IN REPLY REFER TO:  
3482, SL-070645  
U-06039, (UT-923)

Re: Minor Modification of Resource Recovery and Protection Plan (R2P2), Rilda Canyon  
Ventilation Breakout, Hiawatha Seam, Deer Creek Mine.

## RILDA CANYON FAN PORTAL DEVELOPMENT PLAN

**ENERGY WEST  
MINING COMPANY**  
HARRISON, UTAH 84403  
**DEER CREEK MINE  
RILDA CANYON INTAKE PORTAL  
BREAKOUT - PLAN VIEW**

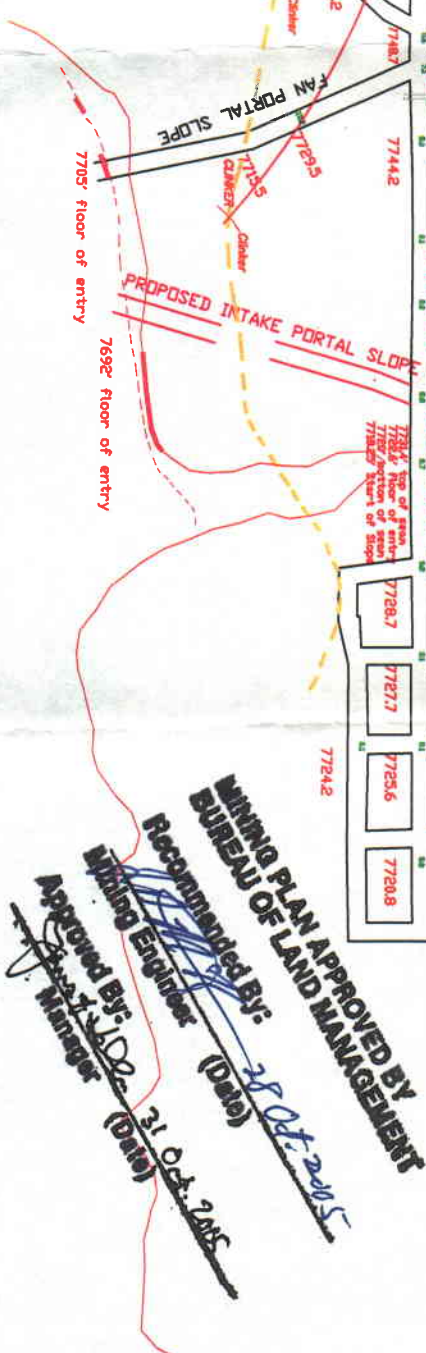
The modification of the R2P2 complies with the Mineral Leasing Act of 1920, as amended, the regulations at 3480, and the lease terms and conditions and will achieve maximum economic recovery of the federal coal. The modification to the R2P2, as depicted on Map CM-10899-DR revised 3-9-04, is approved as submitted. A copy of the approved mine map is enclosed. If you have any questions, please contact Steve Rigby at the Price Field Office (435) 636-3604 or Jeff McKenzie of my staff at (801) 539-4038.
